TRIM—PASSENGER SEAT RUBS AGAINST DOOR PANEL

Article No.
03-1-5

FORD: 1999-2003 MUSTANG

Figure 1 - Article 03-1-5

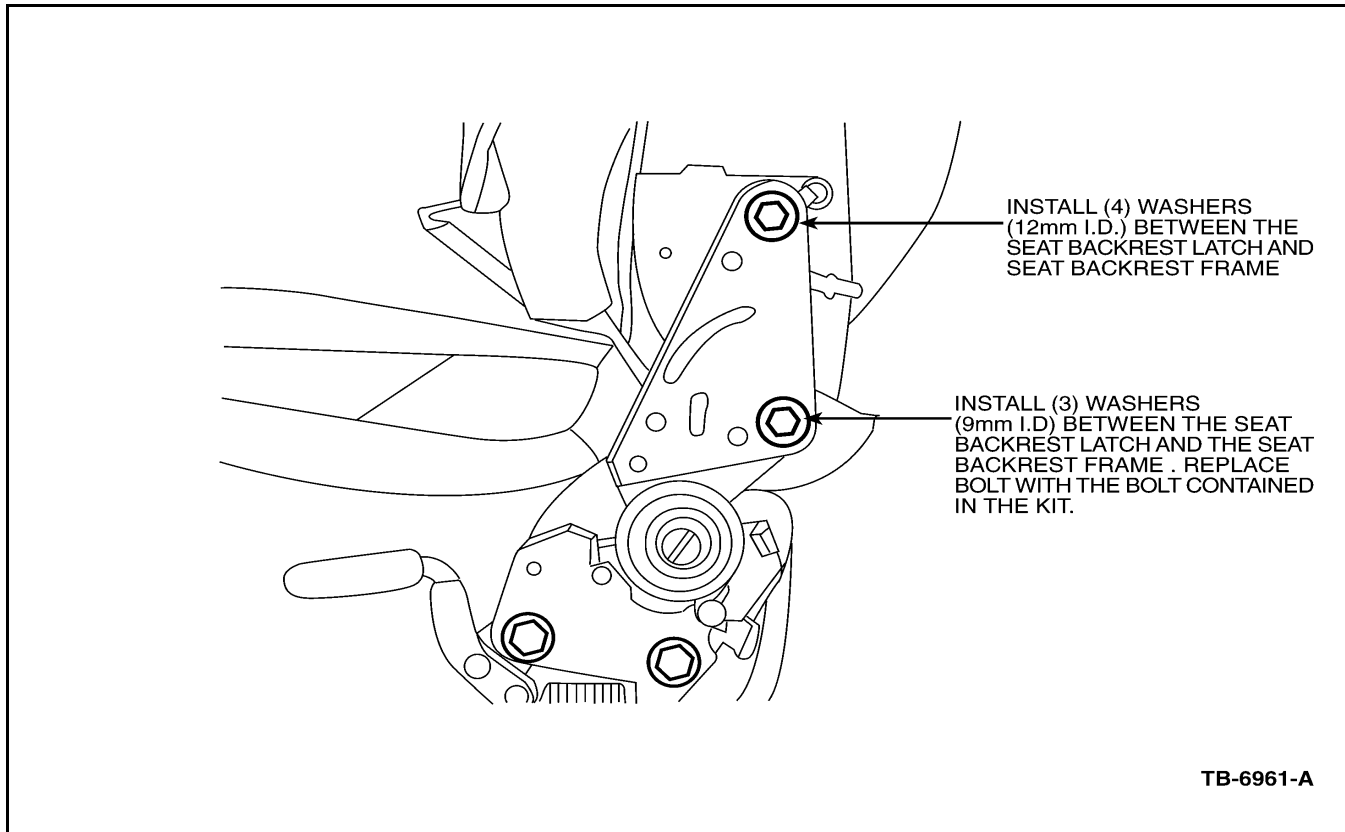
1. Remove the front passenger seat per Workshop Manual procedure listed in Section 501-10.
2. Remove the front passenger seat backrest and latch per Workshop Manual procedure listed in Section 501-10. Only remove the top two bolts of latch (Figure 1). Discard lower bolt.

5. Install other four (4) of the 1.5mm-thick washers between the seat backrest latch and the seat backrest frame at the upper bolt location (Figure 1).

6. Install the three (3) 2mm thick washers (smaller I.D.) between the seat backrest latch and the seat backrest frame at the lower bolt location (Figure 1).

Figure 2 - Article 03-1-5

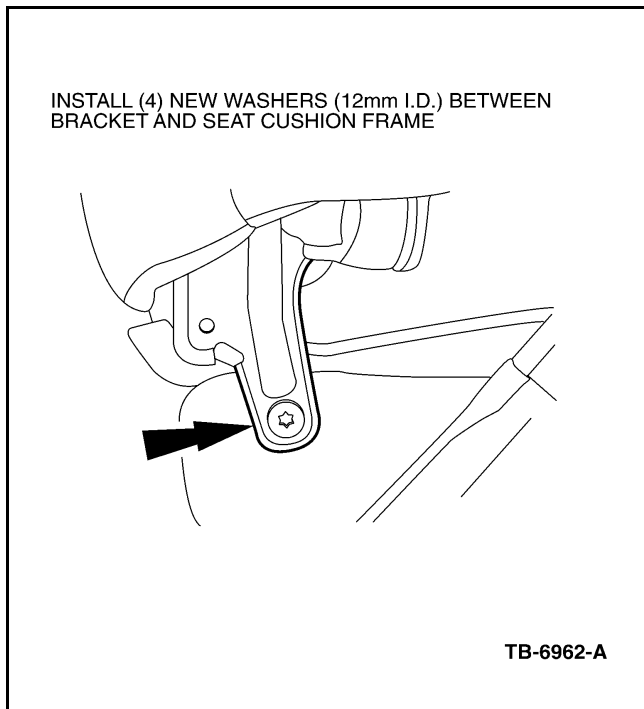
3. Obtain Seat Shim Kit 1R3Z-63000A25-AB.
4. Install four (4) of the 1.5mm-thick washers (8 included in kit with a 12.1- 12.4mm I.D.) between the seat backrest bracket and the seat bottom cushion frame (Figure 2).
